City of Portland, Maine – Building or Use Permit Application 389 Congress Street, 04101, Tel: (207) 874-8703, FAX: 874-8716

Proposed Project Description: Enclose porch Int Renovations				Signature:		INSPECTION: Use Group: Type:		
				Signature:		Signature:		
				Signature:		Date:		
Permit Taken By: Mary Gresik				Date Applied For: 06 October 1997

BUILDING PERMIT REPORT

AMENDMENT to Weymouth Building Permit.

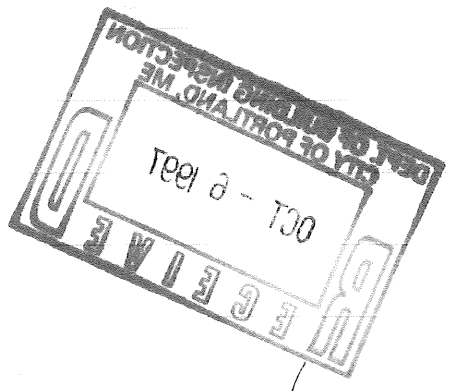
9. Other requirements of condition Any open porch existing with a roof over the same on June 5, 1957, and encroaching upon any yard required by this article, may be enclosed if the major portion of the enclosure is of glass. (14-42)
